February 13, 1999

Our ref: L99007  
Your ref:

### **Emmanuel Road closure and related proposals**

*East Road at the Grafton centre car park exit. Cyclist wanting to stay on the road are met with this island, at which motorists are reluctant to allow them to join the traffic stream. (The pictured cyclist actually cut across the hatching, ignoring all the markings).*

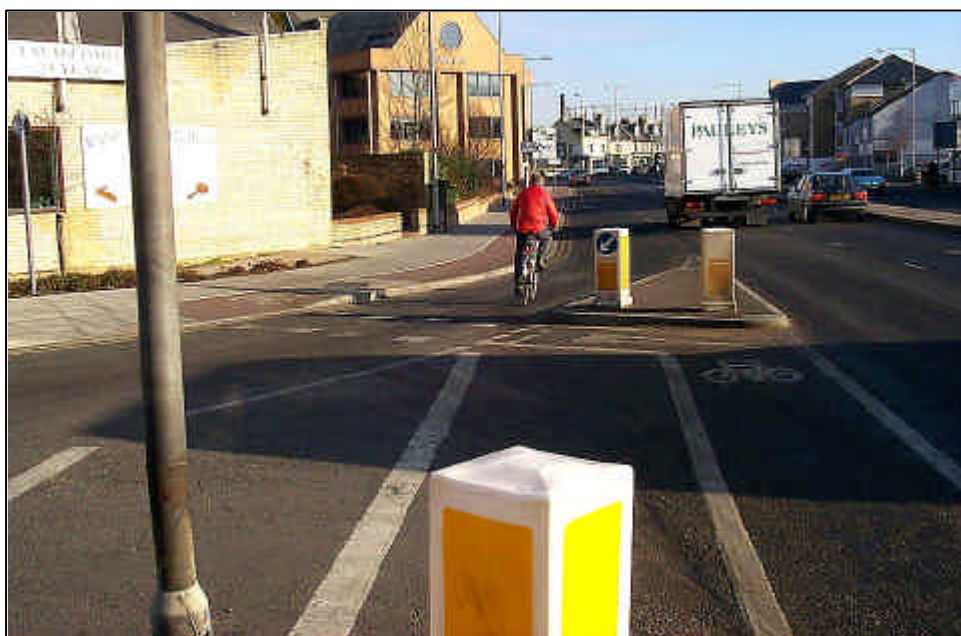
The way in which the cycle lane at the car park exit ends up on the footway has long been a source of complaint from our members. Many cyclists prefer to stay on the road, especially now that Elizabeth Way roundabout has signals, and the present arrangement is unnecessarily hazardous for them. We think both movements can easily be accommodated. (See also, National Cycle Network design guidelines page 51).

*Our suggestions building on your Downing Street junction proposal*

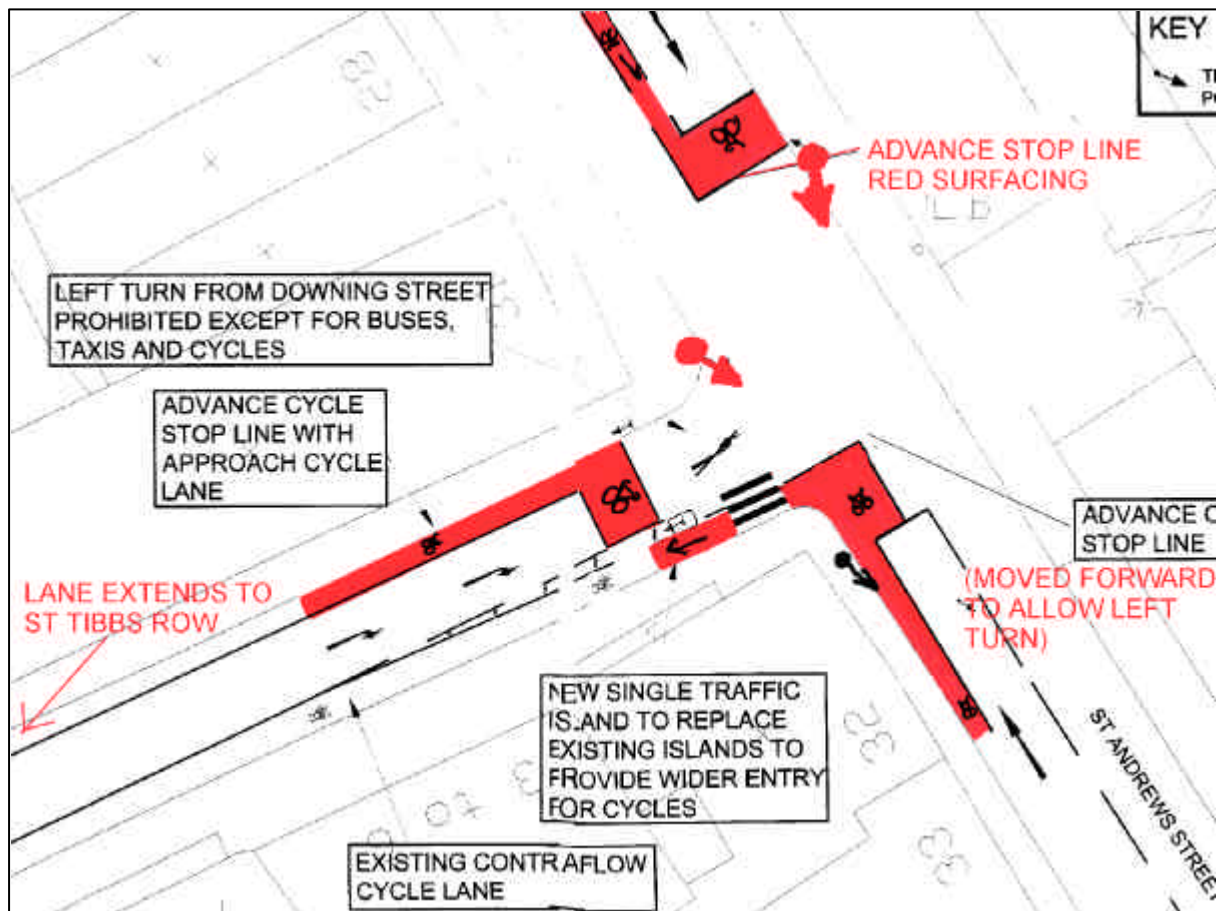
We think, however, that this is a golden opportunity to allow cyclists to make left turns into Downing Street without needing to stop at the red signal.

While a left turn filter with a 'no left turn except cyclists' together would achieve the desired result, we think a simpler solution is to put the cyclists forward stop line beyond the line of the island. The opposing red lights are perfectly well visible, but the motorists' stop line, being well back, would need a signal there. At one time, that would have required a cycle exception. However, this is clearly no longer necessary as the illustrated arrangement in York shows. Here cyclists do not have to wait at the red light at all, and this is indicated only by the stop line not extending right across the road.

The diagram illustrates what we have in mind.

*Groningen, Netherlands: vehicles give way to cycles (with appropriately emphatic signing) where the road narrows. The area behind the cyclists is the end of a cycle lane.*

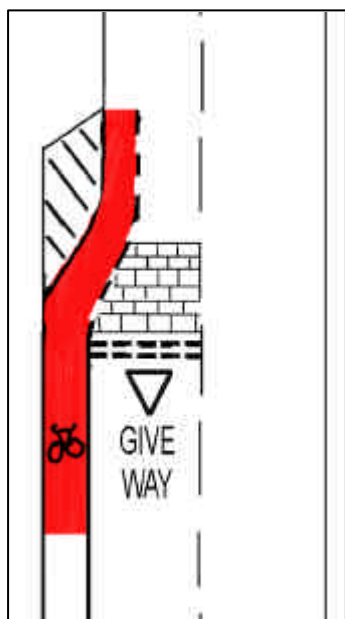
However, we think there is scope here to be more radical, especially as traffic levels should be much reduced in Parker Street. We saw in Groningen in the Netherlands an example of a street where a cycle lane had to end because of a road narrowing. Here the solution they had adopted was to give cyclists priority, as shown in the photograph. We think this would be an innovative answer to a problem where there really isn't room for both streams of traffic to meet.

*... but at least some effort to deflect traffic away from cyclists is needed*

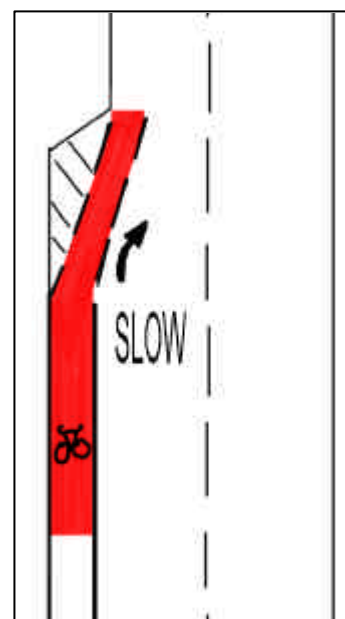
The way in which Parker Street narrows suddenly northbound has long been a concern of ours, and we would very much like this to be addressed. The conflict with large vehicles - buses especially given the location - is probably most serious.

At minimum, we think some hatching and white lining is needed to deflect vehicles further into the road. Again the example in Trumpington Road provides a model. Width is much more limited here, however.
